SIB 54 03 22

BUZZING SOUND HEARD IN THE SKY LOUNGE ROOF

This Service Information Bulletin (Revision 1) replaces SI B54 03 23 **dated October 2022**.

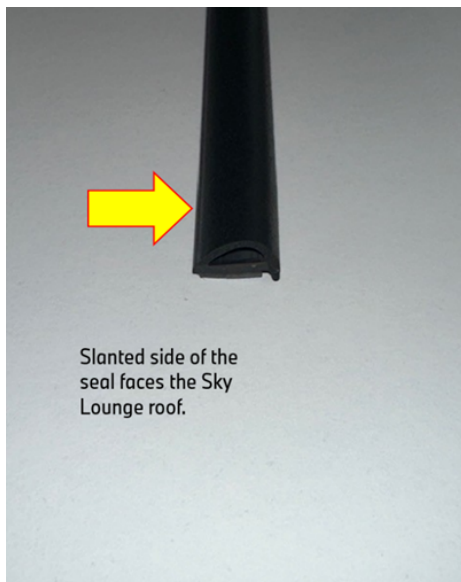
At high outside temperatures, the inner roof trim seal will become soft. Therefore, causing the inner roof trim seal to flap against the Sky lounge roof while at highway speeds.

Install sunroof surrounding seal onto the Sky lounge roof frame.

PROCEDURE

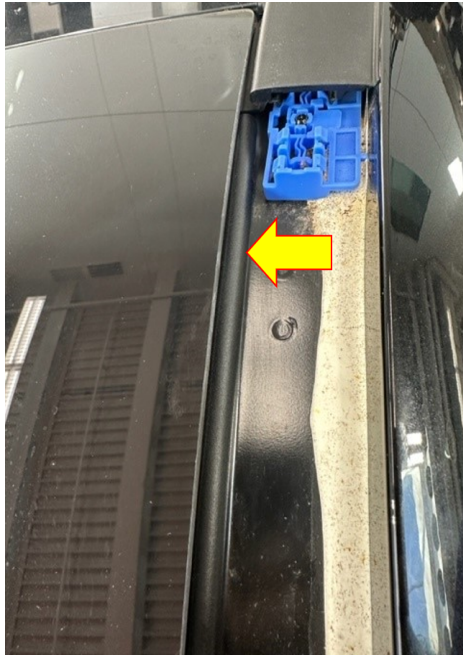
Verify that a buzzing sound from the Sky Lounge roof is heard. If yes, continue to step 1.

1. Remove the roof trim following the repair instructions listed in ISTA/AIR (51 13 280).
2. Using surrounding seal, cut a length of **1965 mm**.

- **Two pieces left and right side.**

3. The slanted side of the seal faces the Sky Lounge roof.

4. Attach the seal to the Sky Lounge roof frame.

5. Install the roof trim back on the vehicle and verify repair.
